COUNCIL ASSESSMENT REPORT
SYDNEY WESTERN CITY PLANNING PANEL

PANEL REFERENCE & DA NUMBER	PPSSWC-557- DA-240/2025
PROPOSAL	Construction of a childcare facility at 234 Edmonson Avenue, Austral.
ADDRESS	234 Edmondson Avenue, Austral
APPLICANT	Baini Design Pty Ltd
OWNER	P R Holdings (NSW) Pty Ltd
DA LODGEMENT DATE	19 May 2025
APPLICATION TYPE (DA, Concept DA, CROWN DA, INTEGRATED, DESIGNATED)	Development Application
REGIONALLY SIGNIFICANT CRITERIA	Clause 3, Schedule 6 of State Environmental Planning Policy (Planning Systems) 2021: CIV over \$5 million
CIV	\$5,676,802.00 (including GST)
CLAUSE 4.6 REQUESTS	No Clause 4.6 has been submitted
KEY SEPP/LEP	State Environmental Planning Policy (Biodiversity and Conservation) 2021 State Environmental Planning Policy (Resilience and Hazards) 2021 State Environmental Planning Policy (Transport and Infrastructure) 2021 State Environmental Planning Policy (Precincts – Western City Parkland) 2021 Liverpool Growth Centre Precincts Development Control Plan 2021 Child Care Planning Guideline 2021

SPECIAL INFRASTRUCTURE CONTRIBUTIONS (S7.24)	N/A
RECOMMENDATION	Refusal
DRAFT CONDITIONS TO APPLICANT	N/A
SCHEDULED MEETING DATE	N/A
PLAN VERSION	N/A
PREPAR

Image of close proximity of pedestrian entry gate and driveway

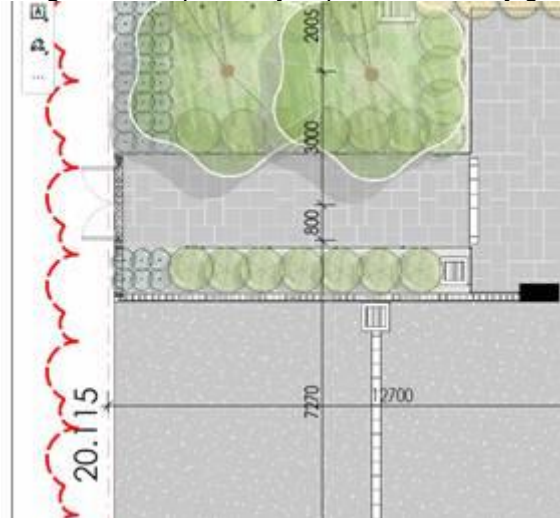
1.2. The main pedestrian entry almost directly adjacent to the driveway is a compromised design outcome and safety issue. In developments generally pedestrian entries should be separated from entry driveways as much as possible. Currently families will be congregating at the front entry gate which is only 1-2m from vehicles turning into the driveway. CDPD encourages exploration of creating greater separation and safety between these entries, to prevent conflicts with families and the driveway.
